## **Response to Reviewer #1**

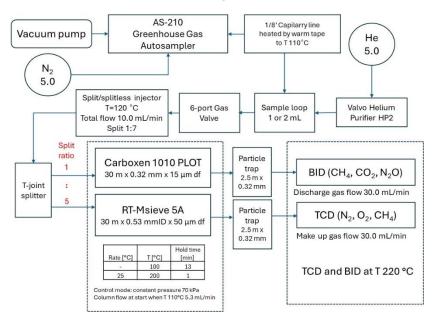
The schematic configuration of GC system for simultaneously measurement of CO2, CH4, and N2O should be provided to get better understanding of the this measurement

Thank you for this suggestion, this will be definitely helpful for the readers. The following scheme will be added to Section 2.1, as Figure 1

Figure 2A – presented below

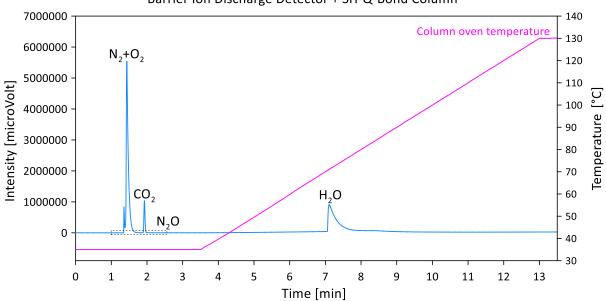
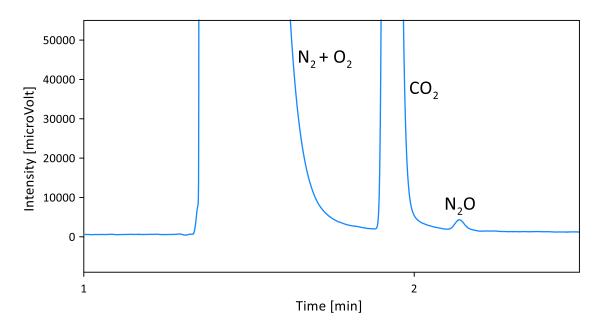
The peak label (name) for identification of gas component cannot be seen clearly (too small) both in the picture and inset of picture

The previous version contained the picture obtained using GC Software Lab Solutions dedicated for GC made by Shimadzu. In the response for Reviewer's comments the data of chromatograms were exported from Lab Solutions as ASCII file and therefore converted to prepare new plots using Grapher Golden Software. Here we present the new Figure 2A and 2B (zoomed Figure 2A) which will be added to the revised article.

New Figure 3 will be corrected as below:

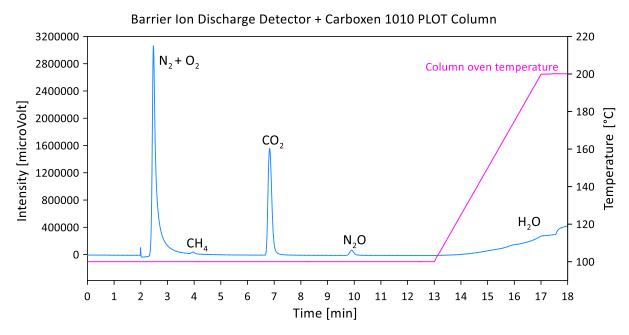
The peak label (name) for identification of gas component cannot be seen clearly (too small) both in the picture and inset of picture

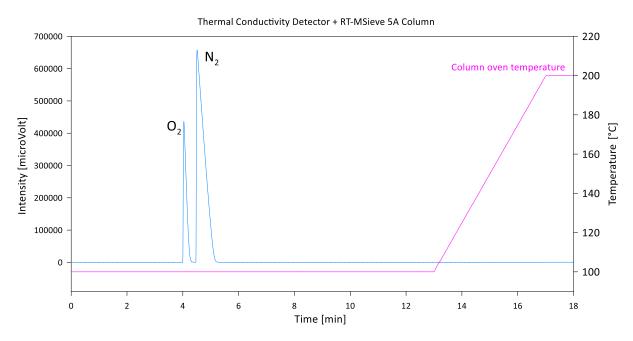
In this section, can  $O_2$  and  $N_2$  be separated well by the GC system and detected by TCD? because in section 3.1, the  $O_2$  and  $N_2$  peaks overlapped when analyzed with GC BID as seen in the chromatogram in Figure 2.

## The separation chromatogram for analysis in the GC system in section 3.2 can be displayed

Yes, in all configurations the system allow for separation of  $O_2$  and  $N_2$  by molecular sieve 5 A connected to TCD. The chromatogram with separation using this column will be added to manuscript as below:

Yes,  $N_2$  and  $O_2$  in our GC system can be separated with application of RT-MSieve 5A column with detection using TCD. The range of detection is from 0.2 to 100% (for  $N_2$  and  $O_2$ ). This is very important especially for analyses of microbial samples (cultivation experiments) to control the aerobic or anaerobic conditions in the headspace gas. Moreover, in our system we have potential to separate argon from ambient air using cryogenic option (decrease of the column oven temperature to e.g. 0°C by liquid nitrogen (LN<sub>2</sub>)), because RT-MSieve 5A column can work in temperature range of -100 to 300°C. However, if it is necessary to perform an analysis of  $O_2$  concentration at lower concentration (below 0.2%) and detect with BID, Carboxen 1010 PLOT column should be unmounted from the GC system – because its minimal temperature of working is 25°C. It is also possible to separate  $N_2$  from  $O_2$  using SH-Q-Bond column which can work at minimal temperature of -60°C.
